**Final Drainage Plan,
Cherry Creek Crossing Filing No. 1 Lot 111
El Paso County, Colorado**

Kiowa Project No. 14028
August 3, 2017
Revised September 20, 2017
Revised July 19, 2018

Markup Summary

FIG.2

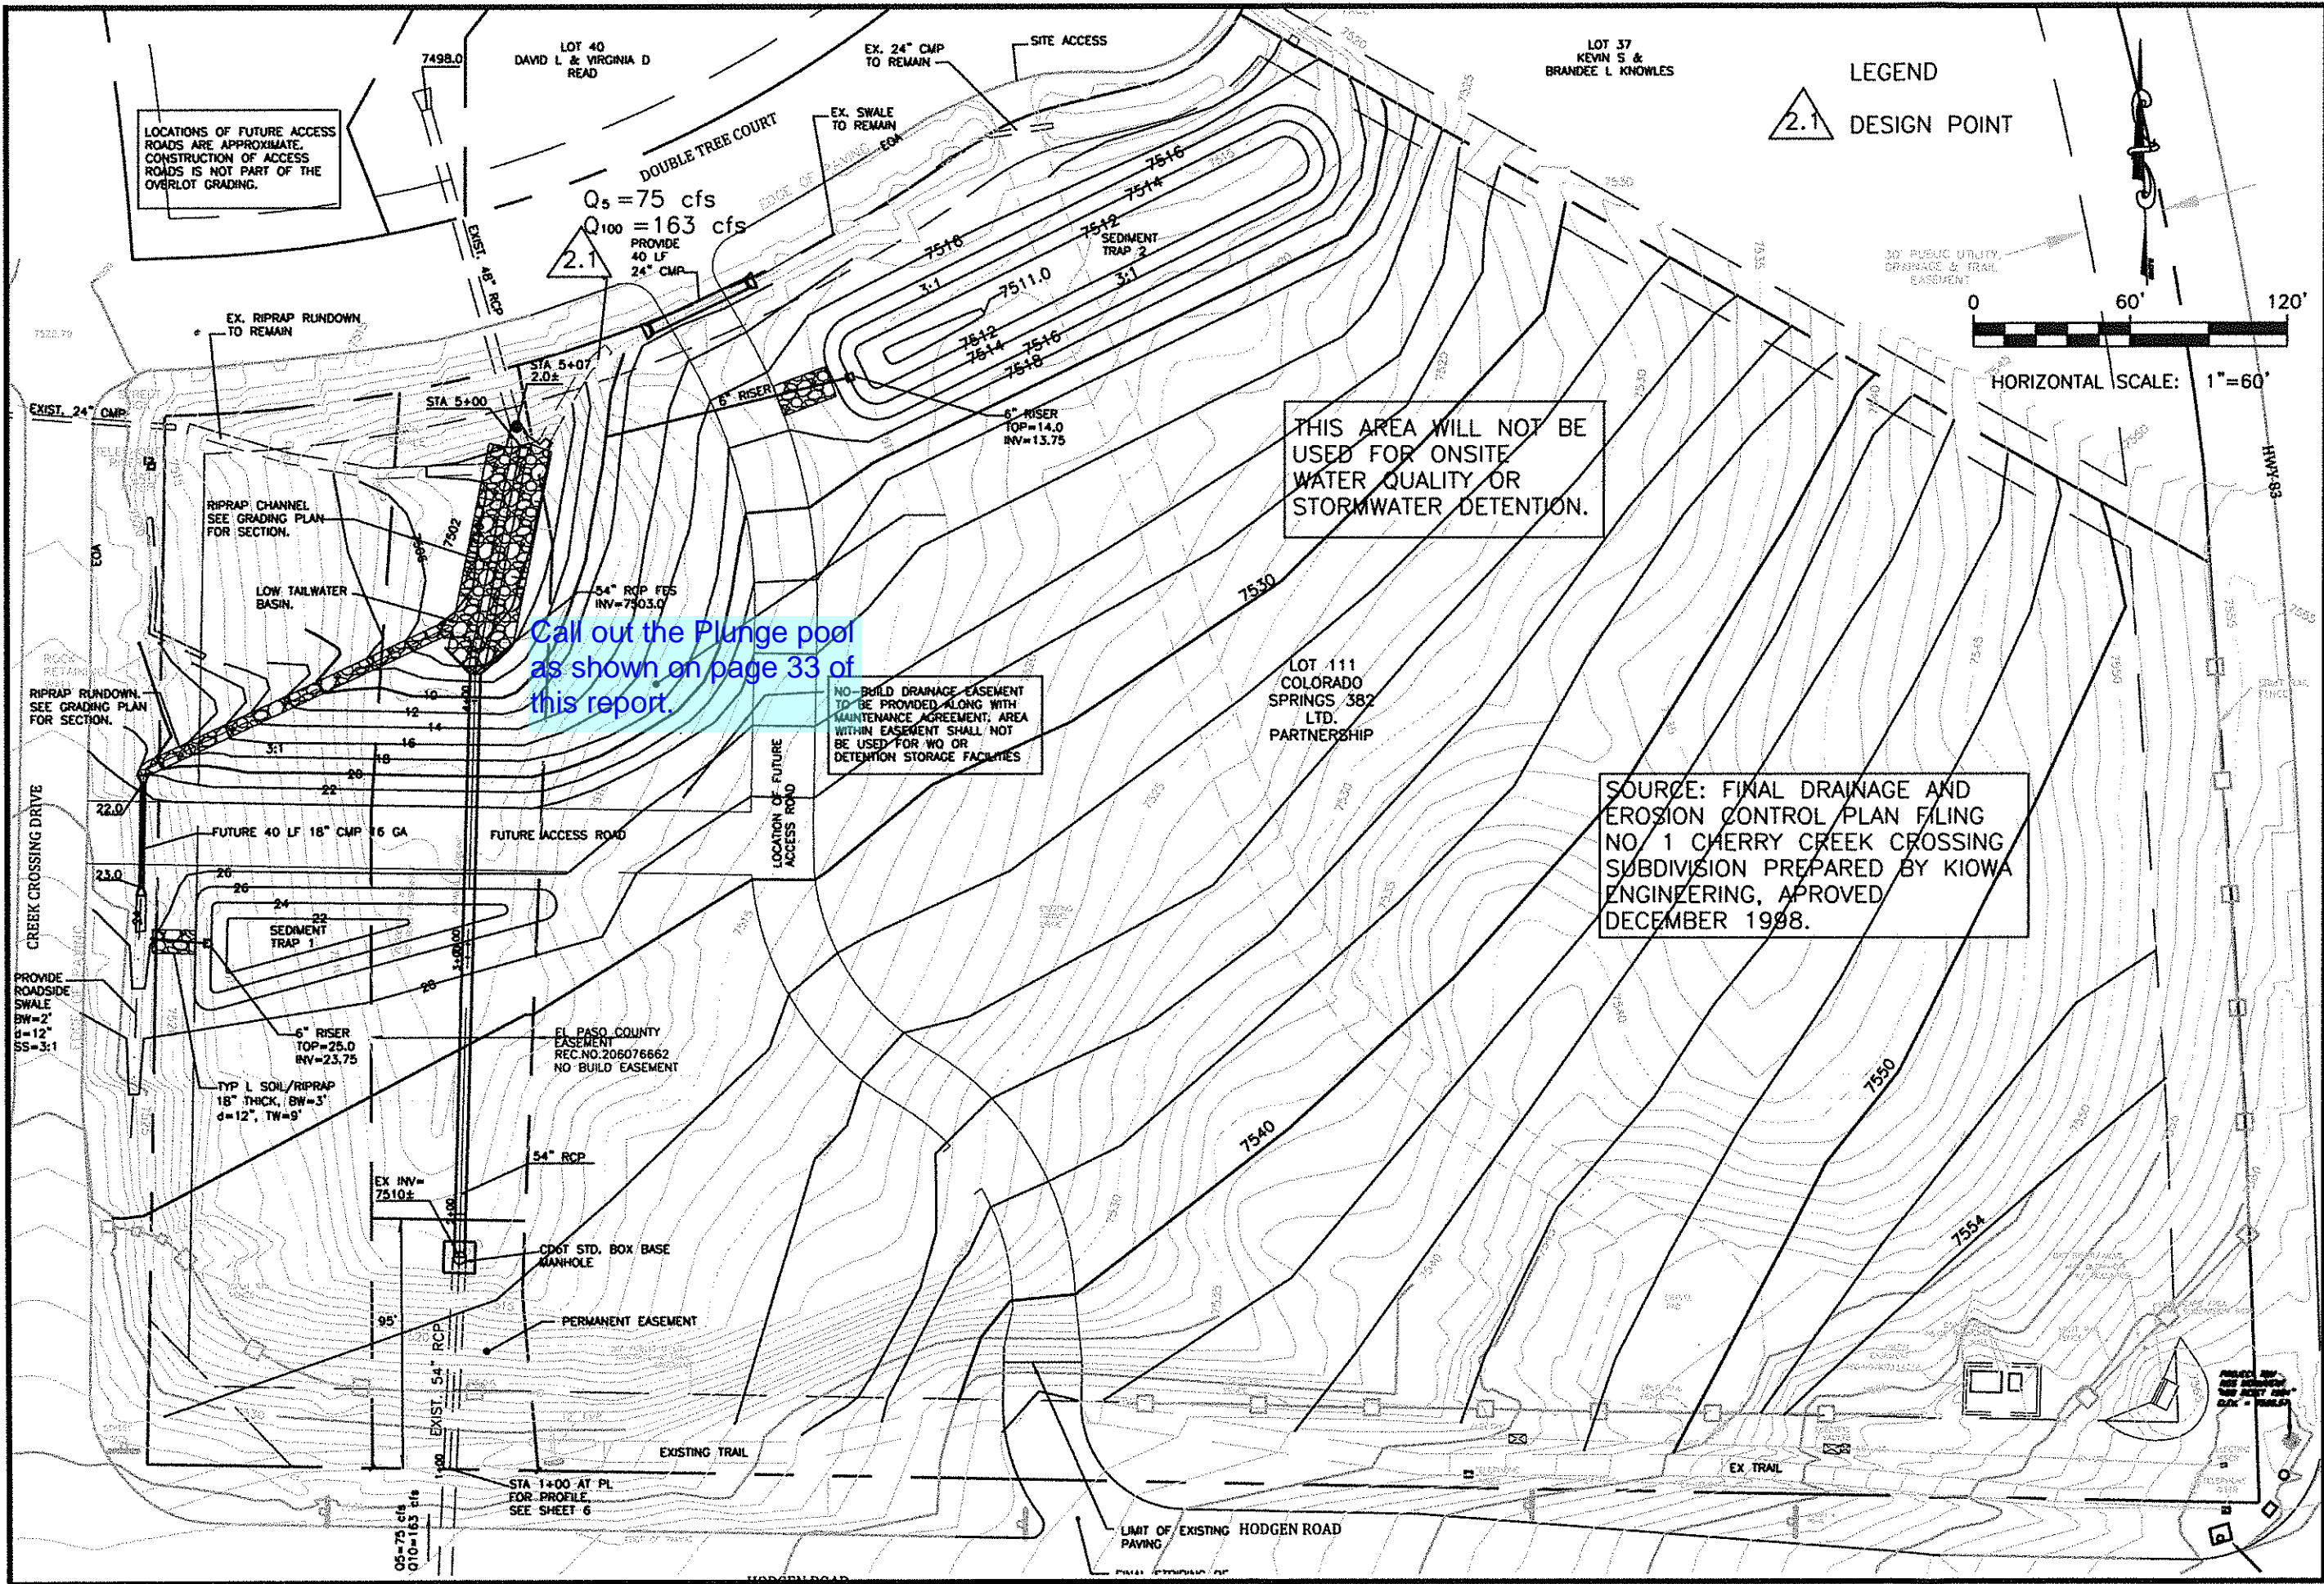
Call out the Plunge pool as shown on page 33 of this report.
